Parcel A of Bannockburn MNCPPC #120180030

Preliminary Plan No. 120180030

Bannockburn - 7009 Wilson Lane

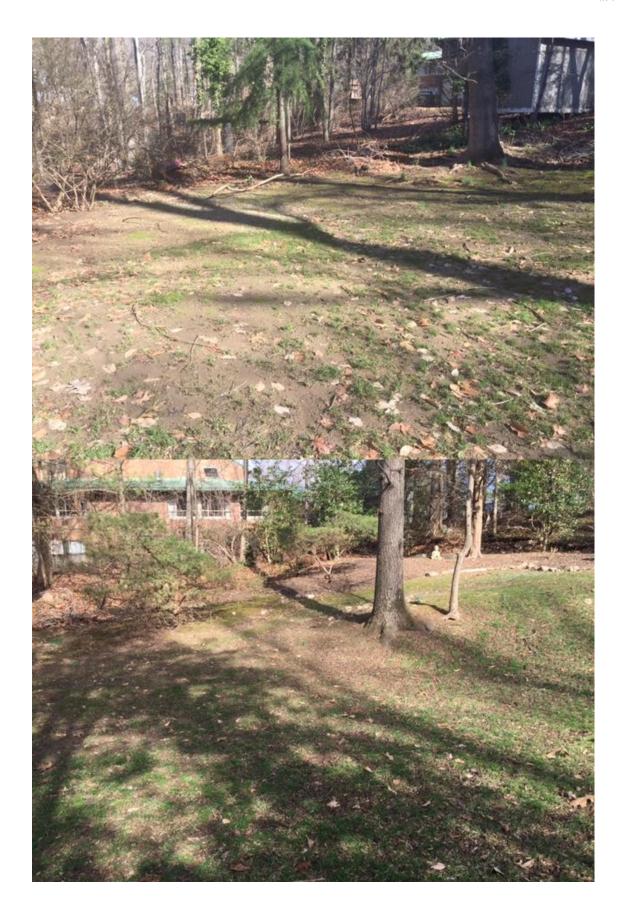
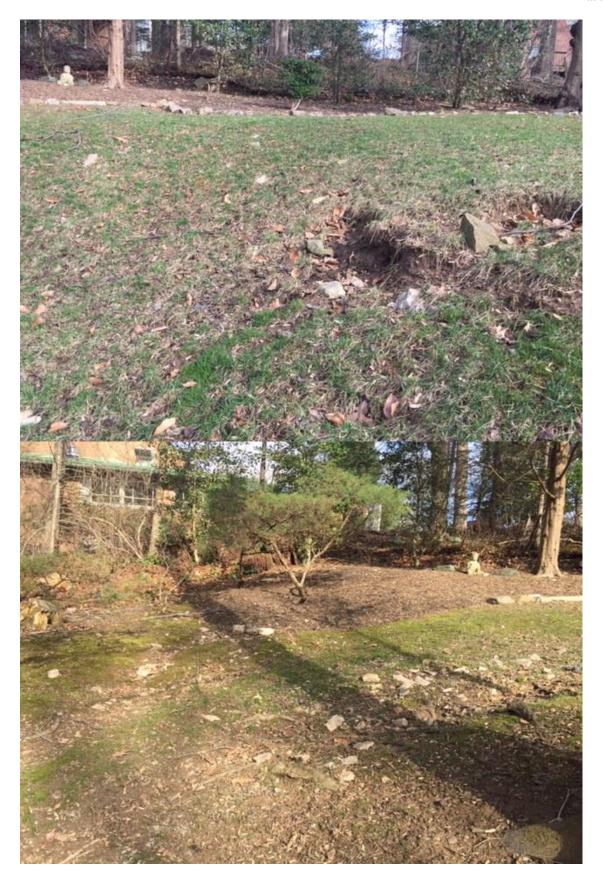
I am attaching pictures showing varying elevations some indications of runoff damage with soil erosion and exposed tree roots.

ATTACHED PHOTOS: Start with looking up toward Parsonage and Church parking lot then down to lower side of property where it continues downhill to stream. Photos in between show along the way bare land where plantings had been soil erosion leaving rocks, land drop off virtual stream bed and now exposed roots. Rainy weather this area runs like a stream from Wilson Lane Parsonage, Church and parking lot side of parcel to continue downhill.

The Applicant clarified in a subsequent submittal that no land disturbance, such as clearing, grading, demolition, or construction, is proposed as part of this application. As a result, there will be no physical changes to the property, including the addition of storm water management measures.
